date: January 30, 2023
to: Jennifer Hofmeister-Drew, AICP, LCAM, Planner III,
Town of Palm Beach
from: Eric Czerniejewski, P.E., ENV SP
subject: Vineta Hotel Traffic Review

MEMORANDUM

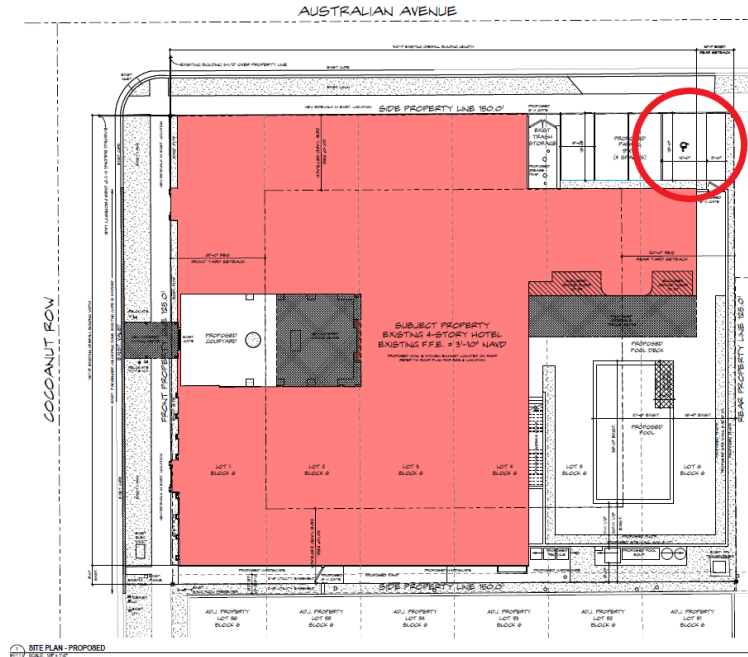
5. Please add the following road segments to Roadway Link Analysis Test 1 and 2 Tables 8 and 9:

- Coconut Row- Royal Palm Way to Australian Avenue (70%)
- Coconut Row- Australian Avenue to Chilean Avenue (30%)
- Hibiscus Avenue- Royal Palm Way to Australian Avenue (15%)
- Hibiscus Avenue- Australian Avenue to Chilean Avenue (15%)
- Chilean Avenue- S County Road to Hibiscus Avenue (15%)
- Chilean Avenue- Hibiscus Avenue to Coconut Row (30%)

Simmons & White's 01/27/23 Response: Change made as noted.

TCG 01/30/23 Response: Addressed.
